City of Portland, Maine – Building or Use Permit Application 389 Congress Street, 04101, Tel: (207) 874-8703, FAX: 874-8716

Location of Construction: 40 Hussey Rd, Peaks Island		Owner: Morten B. Asbjornsen		Phone: 228-0033	Permit No: 980953
Owner Address: P.O. Box 56 P.I. 04108		Lessee/Buyer's Name:		Phone:	BusinessName:
Contractor Name: SAA		Address:		Phone:	
Past Use: Vacant Land		Proposed Use: 1-1/2 story dwelling		COST OF WORK: \$ 25,000.00	PERMIT FEE: \$ 145.00
Proposed Project Description: Construct Single Family Dwelling (16 x 16) 2 1/2 stories		FIRE DEPT. <input type="checkbox"/> Approved <input type="checkbox"/> Denied		INSPECTION: Use Group: Type:	
		Signature:		Signature:	
Permit Taken By: MG		Date Applied For: 14 August 1998

SUBJECT: Certificate of Occupancy
40 Hussey Road, Peaks Island

BUILDING PERMIT REPORT

HOUSE FOR: MORTON ASBJORNSEN - HUSSEY RD - PEAKS ISLAND : PH. 228-0033

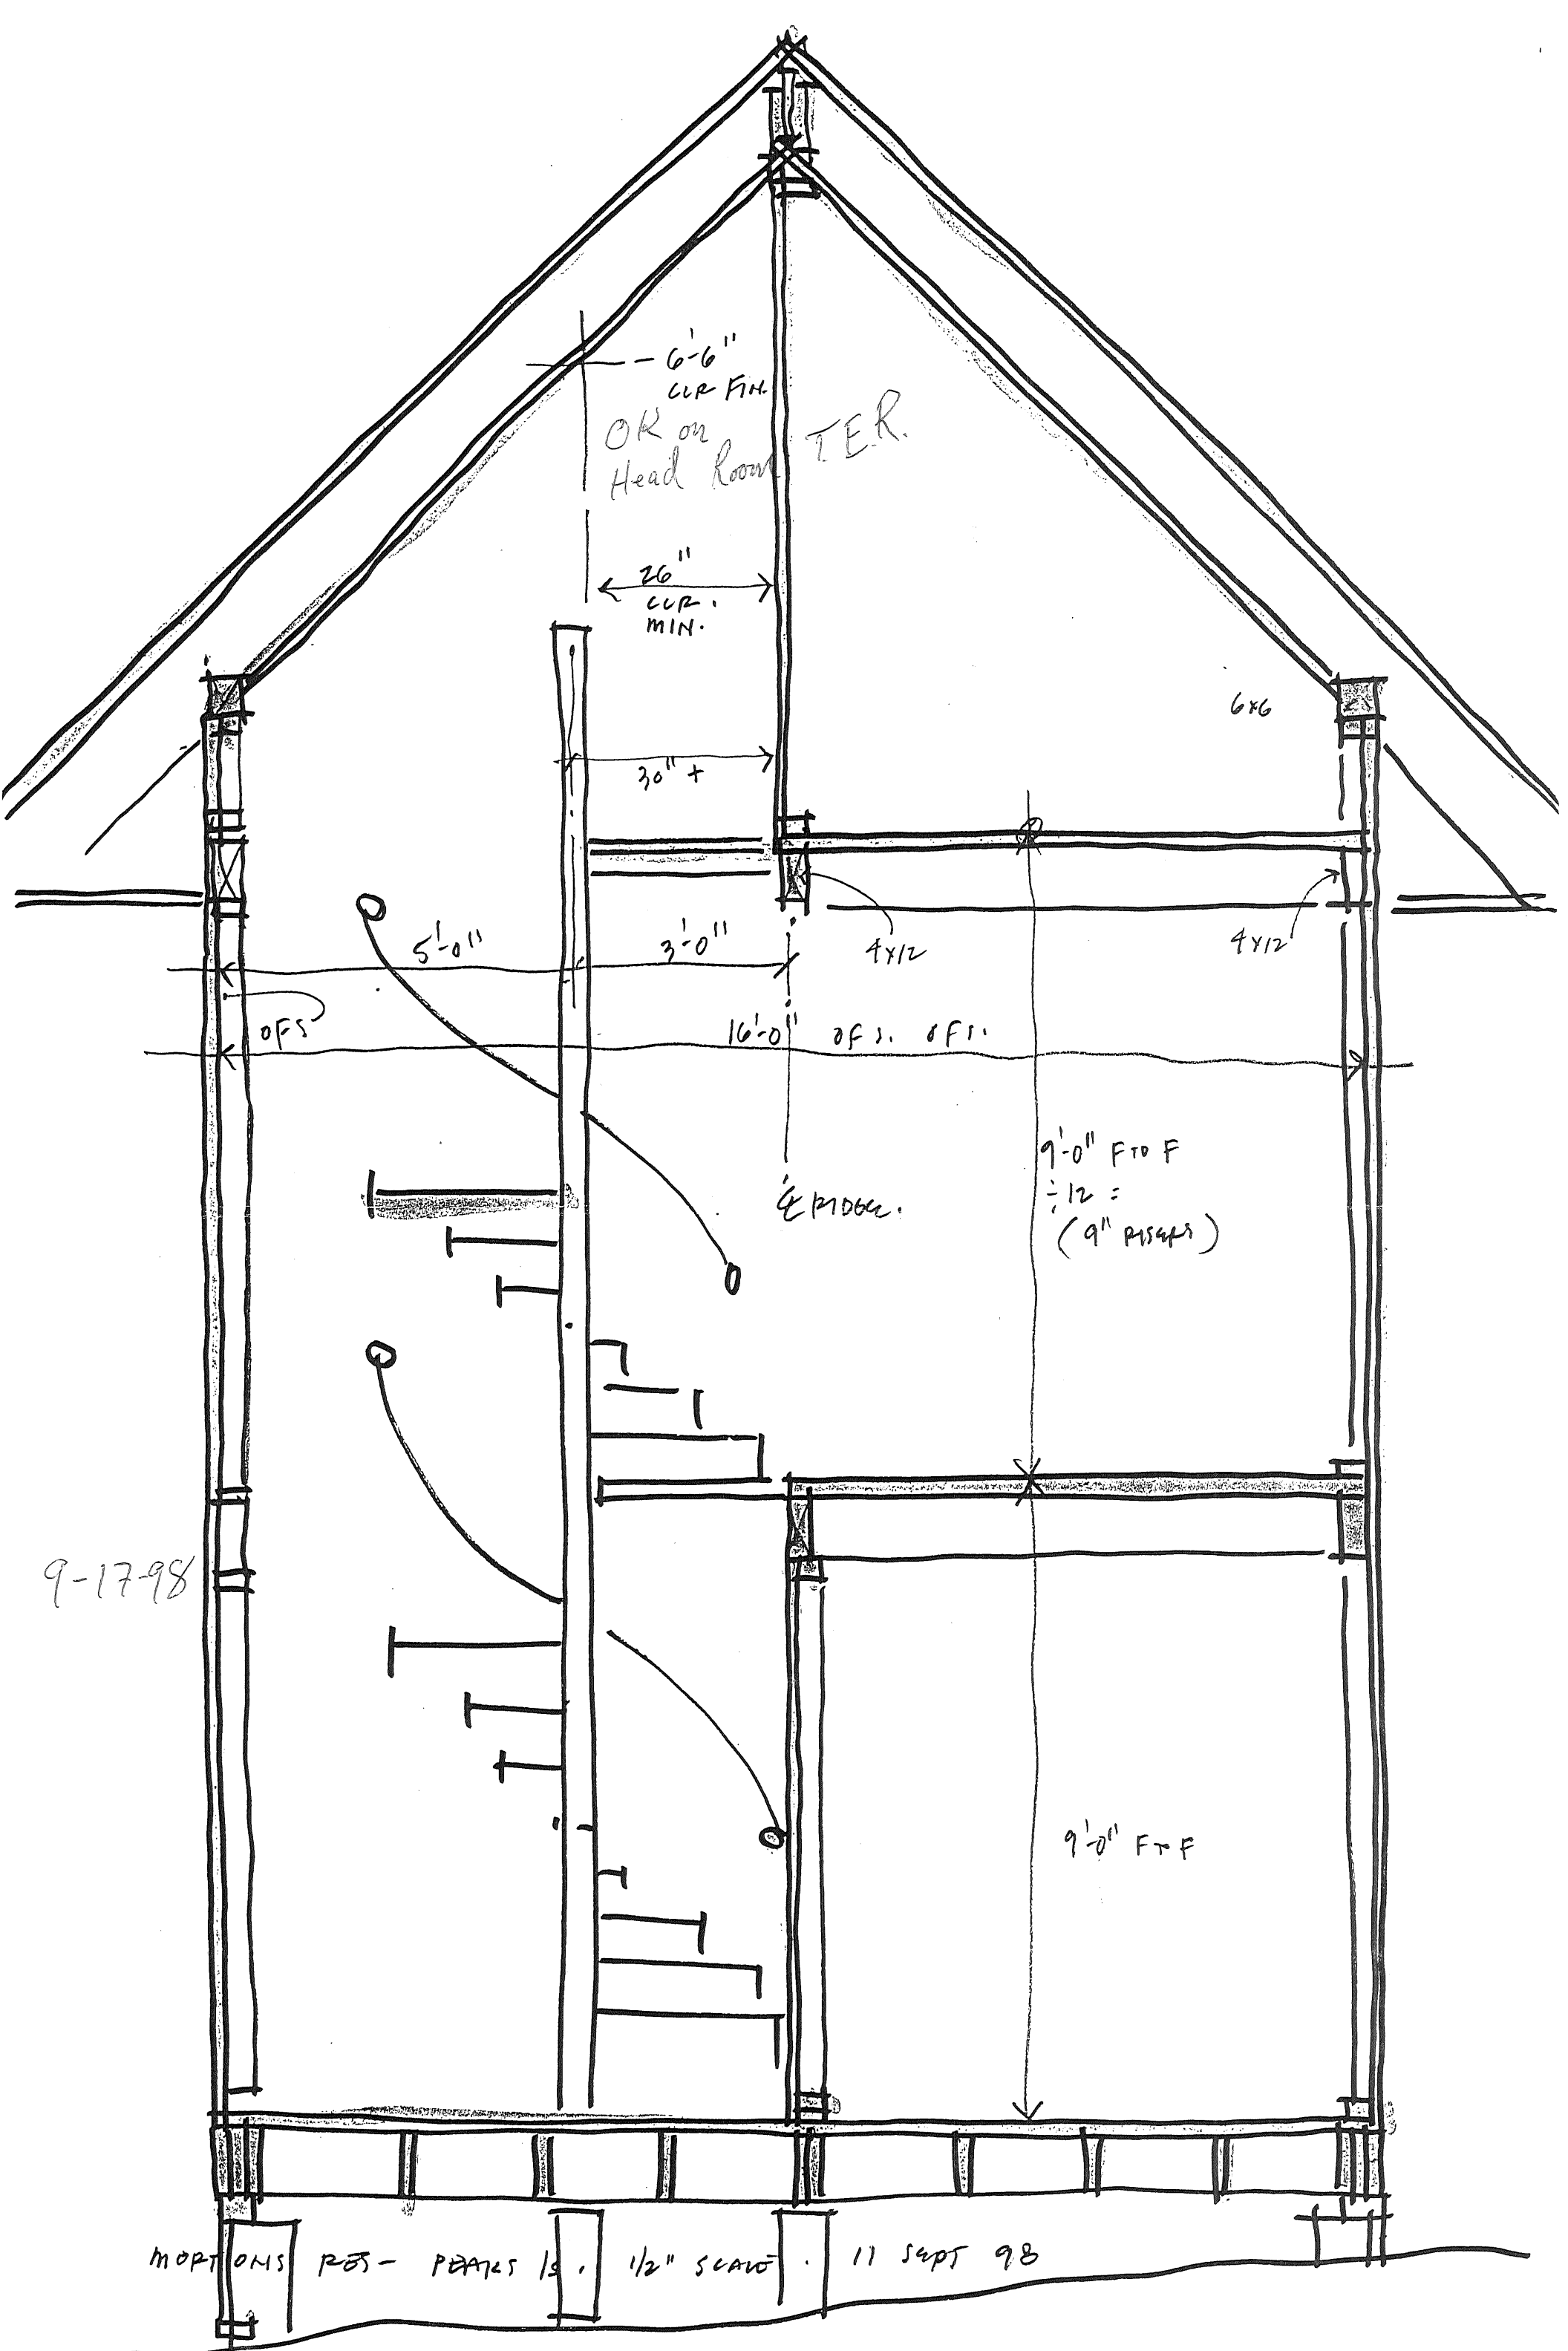
6'-6"
CUR FIN.
OK on
Head Room
TER.

STAIRCASE
CROSS SECTION
SHOWING
TREAD + RISER
DIMENSIONS
& HEADROOM
& SUPPORT
& GUARD RAILS

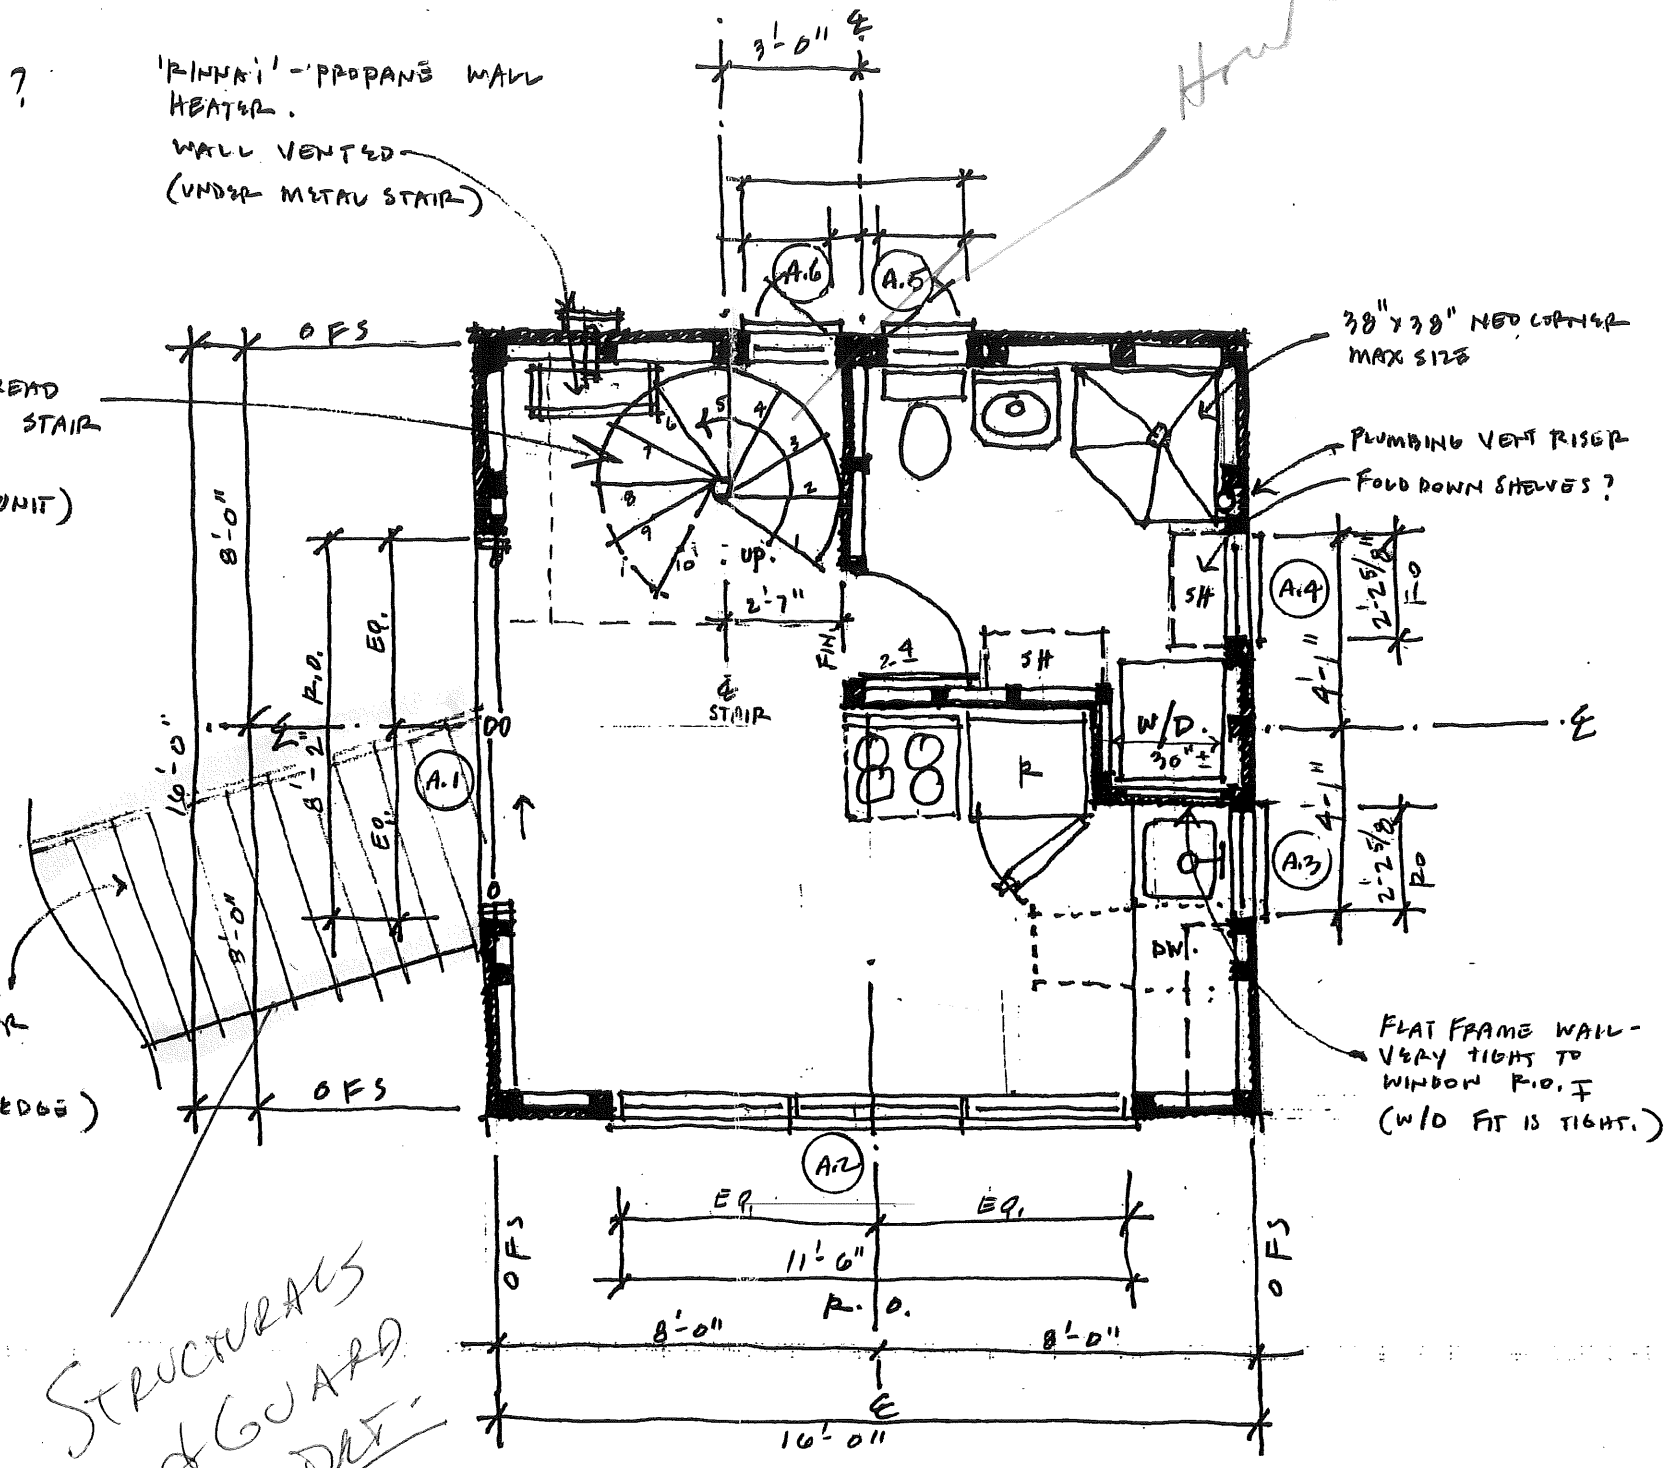
Boca 1014.6.4 does this change from above requirement

TYPICAL WALL CONSTRUCTION:

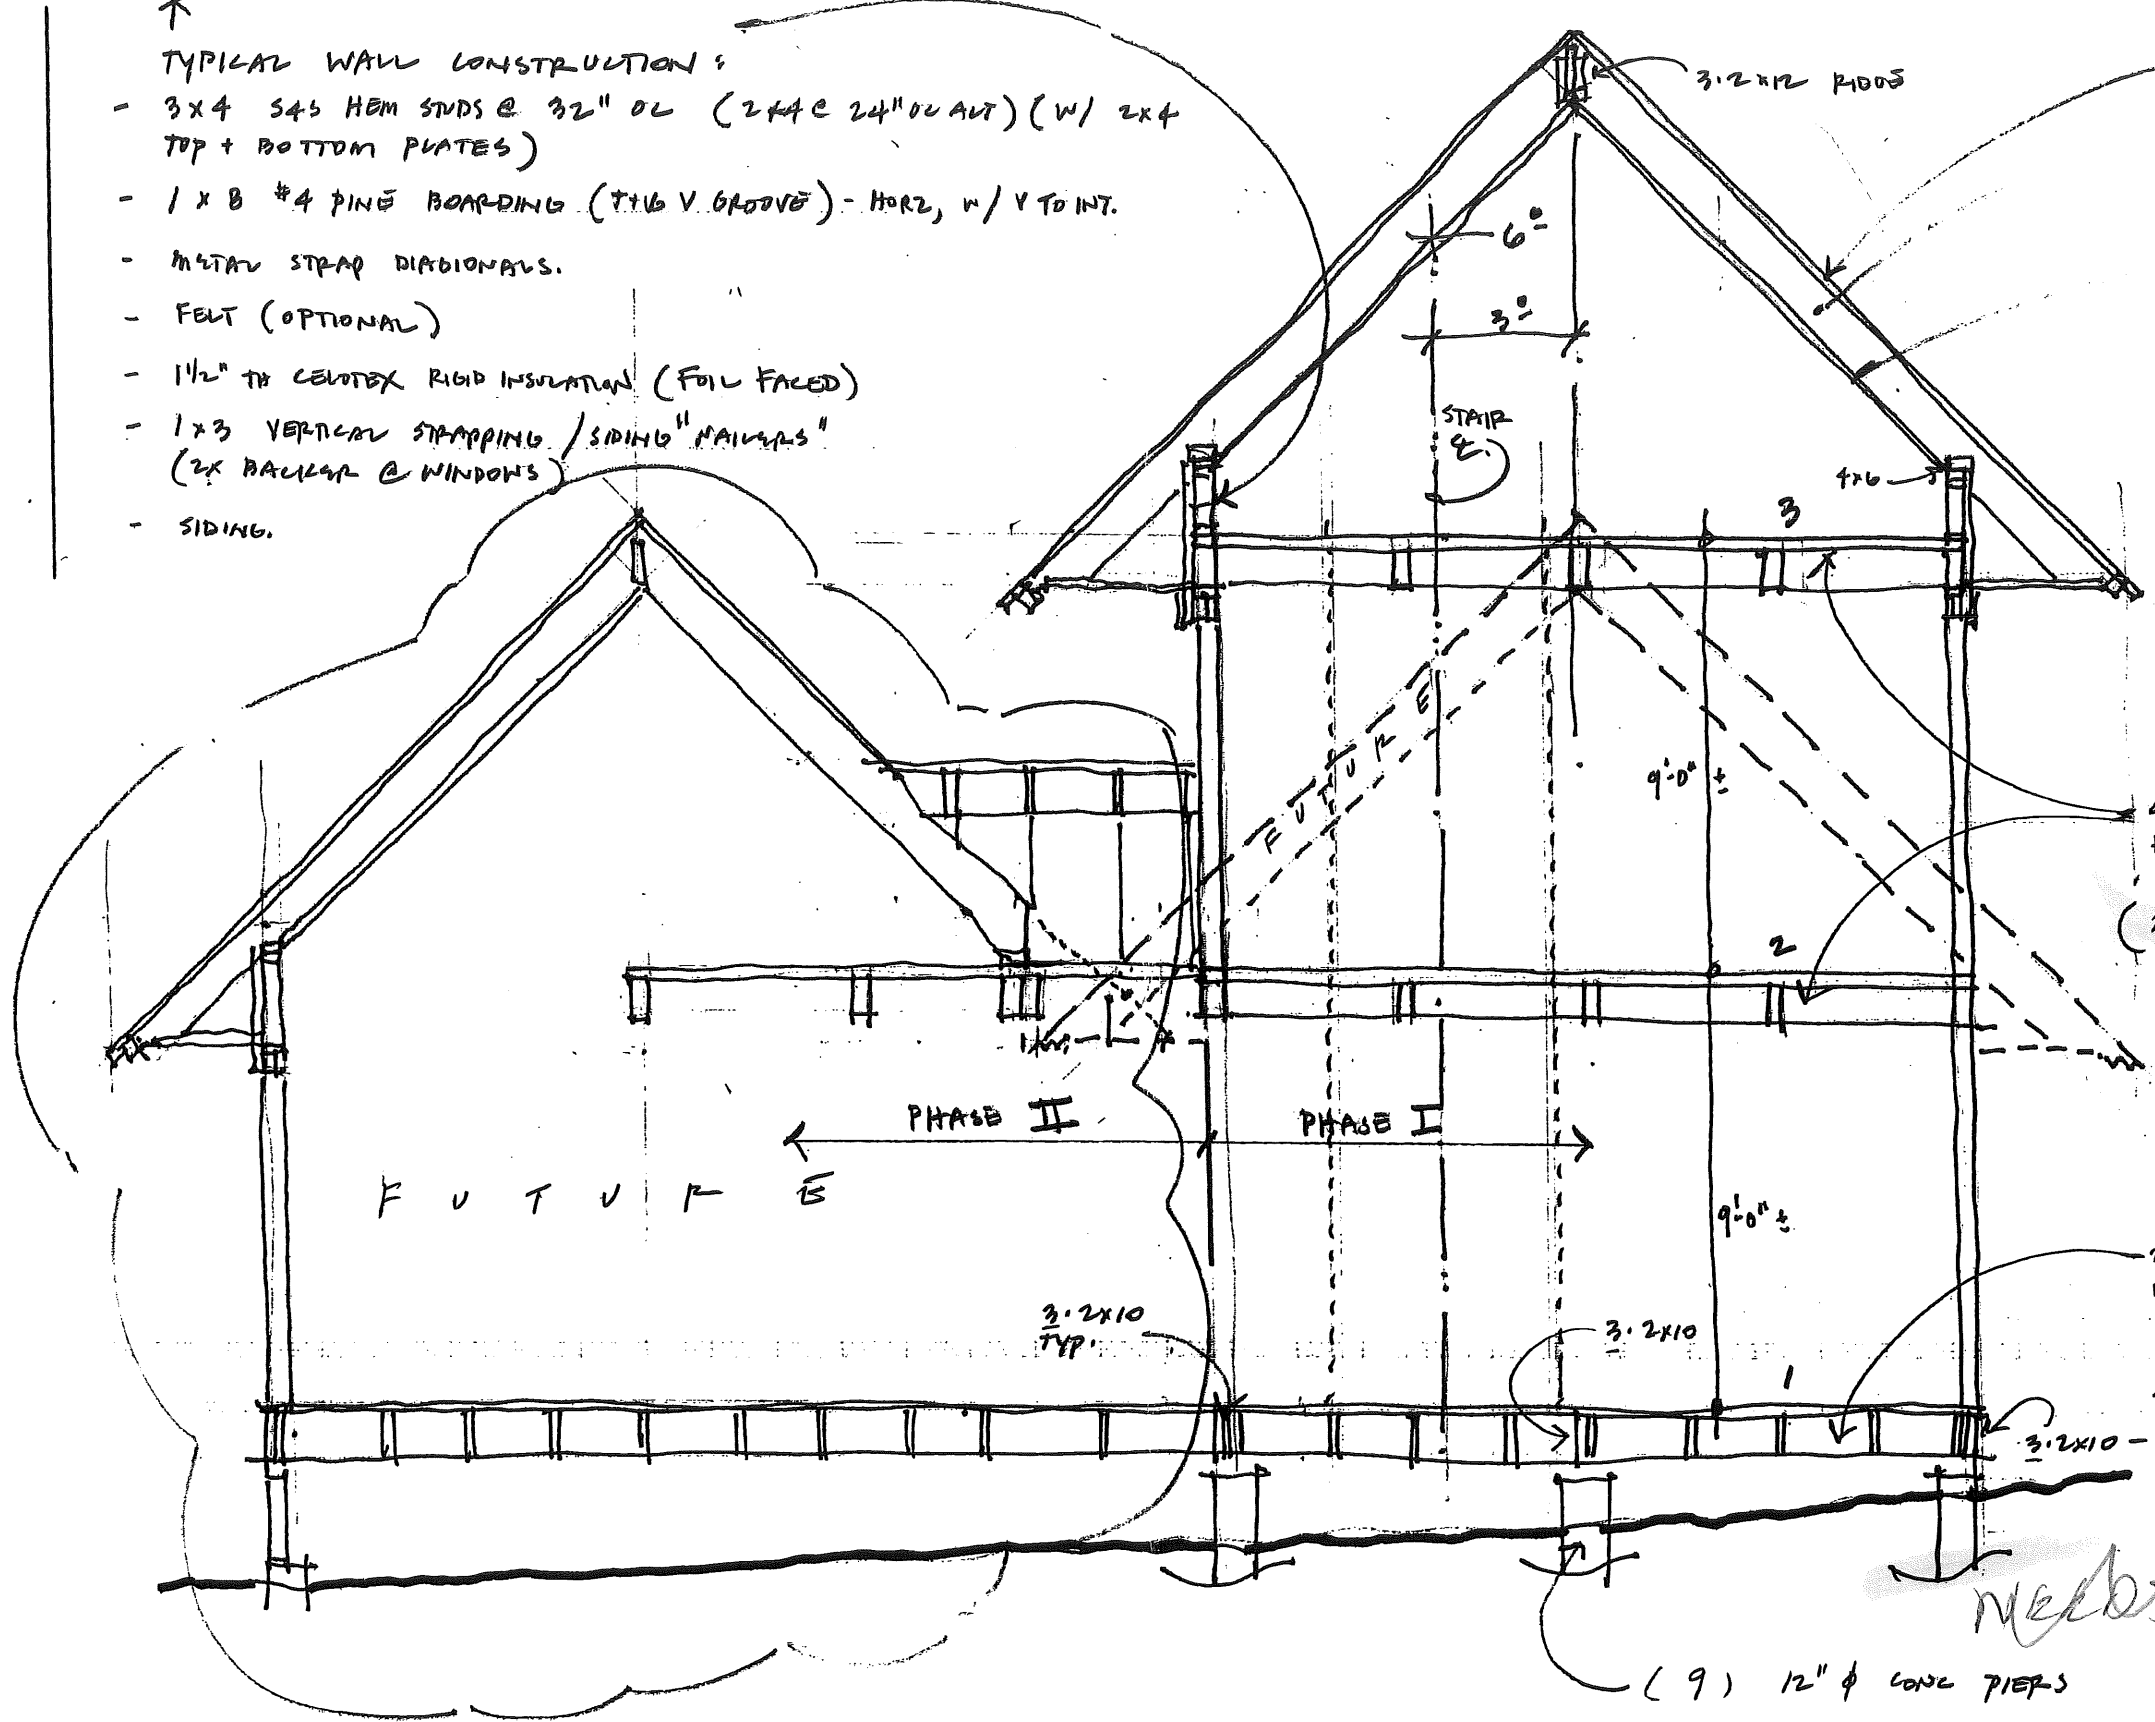
WHAT'S S&S HEM?
 (HEMLOCK SOMETHING)
